8. Well Name and No.
HEIGHT CC 6-7 FEDERAL COM 31H

OXY USA Inc. respectfully requests to swap the SHL for the Height CC 6-7 Federal Com 31H-30-015-45553 and the Length CC 6-7 Federal Com 21H ? 30-015-45574. The wells would still drill their originally permitted laterals hitting their approved FTP and LTP.

OXY USA INC. HEIGHT CC "6_7" FEDERAL COM #31H SITE PLAN

OXY USA Inc. – Height CC 6-7 Federal Com 31H – SHL Amend APD

WELL LOCATION AND ACREAGE DEDICATION PLAT

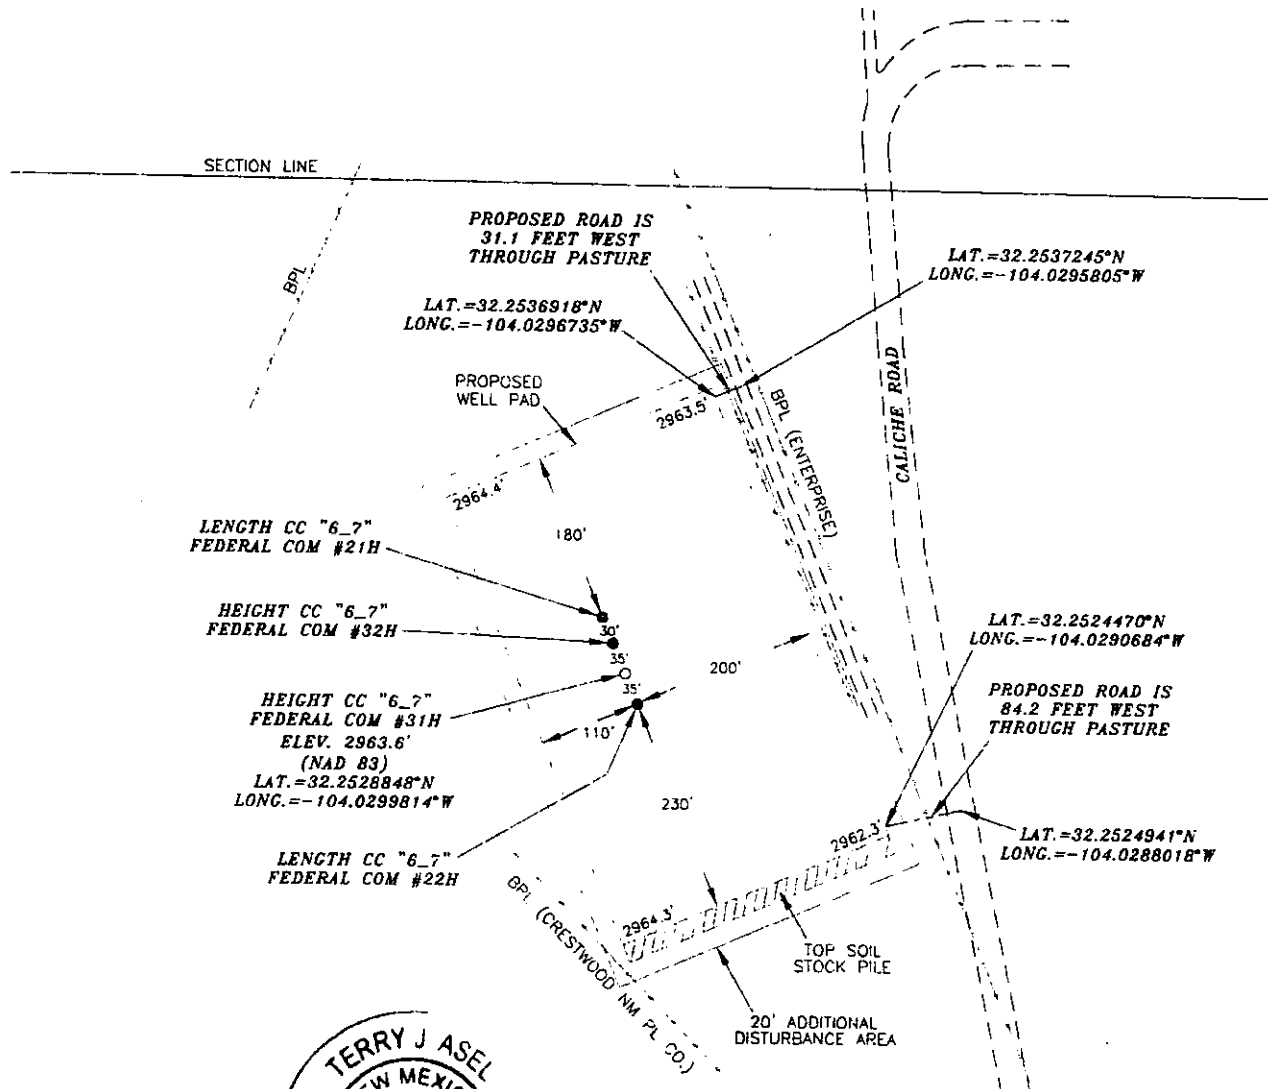
OXY USA Inc. respectfully requests to swap the SHL for the Height CC 6-7 Federal Com 31H-30-015-45553 and the Length CC 6-7 Federal Com 21H – 30-015-45574. The wells would still drill their originally permitted laterals hitting their approved FTP and LTP. The change in total well depth is +/- 70', but overall well construction remains the same. The surface in this area is private surface and no additional surface disturbance would be incurred by making this swap. The driver to make the request is anti-collision concerns with the current slot arrangement. We acknowledge we should have caught the AC issues prior to filing the original sundry, but greatly appreciate the BLM's support in resolving the issue. This SHL swap results in a +/- 70' change in total depth for both wells, but the well design for each well remains the same.

- 2/21/2019 Engineering review completed by m Hague. Operator must run a CBL from TD of the intermediate casing to surface. Submit results to BLM
